DTB

Date: March 15, 2005
Order No.: P-B-42.10/51c
Supersedes: P-B-42.10/51b dated March 1, 2005
Group: 42

SUBJECT: **Model 171.456, from Vehicle Production 03/2004 up to 08/2004**
Model 203.065/076
Model 209.375/475
Model 209.376/476 up to Vehicle Production 06/2004
Model 211.070, up to Vehicle Production 08/2004
Model 215.375/376/378, up to Vehicle Production 08/2004
Model 220.170/175/176/178, up to Vehicle Production 08/2004
Model 230.475, up to Vehicle Production 08/2004
Front Brake Squealing / Grinding Noise

Figure 1 P-B-42.10/51b

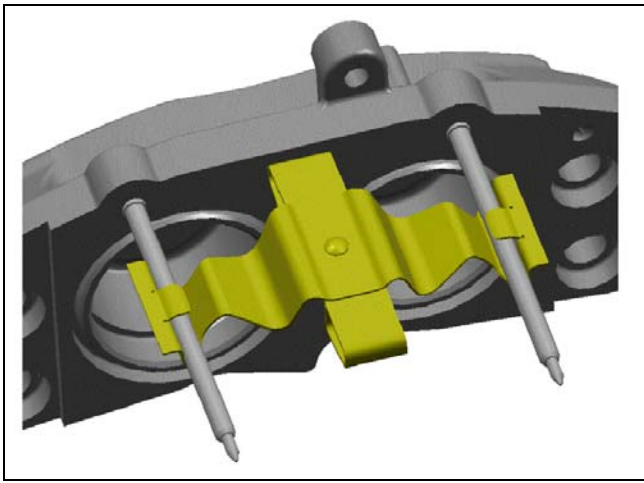
If you receive customer reports in the above model vehicles of a squealing or grinding noise from the front axle area, even when the brakes are not applied, inspect the front brake discs and pressure retaining springs for contact. If contact exists, replace the brake pad pressure retaining spring(s) with modified parts (Figure 1). Reference the following WIS documents – Model 171 - AR42.10-P-1600VA; Model 203/209 - AR42.10-P-1600PF, Model 211/230 - AR42.10-P-1600R and Model 215/220 - AR42.10-P-0161I.

i **Note:** The squealing/grinding noise is the result of the pressure retaining spring slipping out of position and scraping on the face of the brake disc. Each time the brakes are applied, the play within the brake caliper guide channel causes the brake pads to move a short distance in the circumferential direction of the brake disc. This movement is then transmitted to the two retaining pins, which consequently rotate a small amount during each brake application. This rotation is then transmitted to the tabs on the pressure retaining spring, which can cause it to dislodge from its original position.

i **Note:** Only replace the pressure retaining springs.
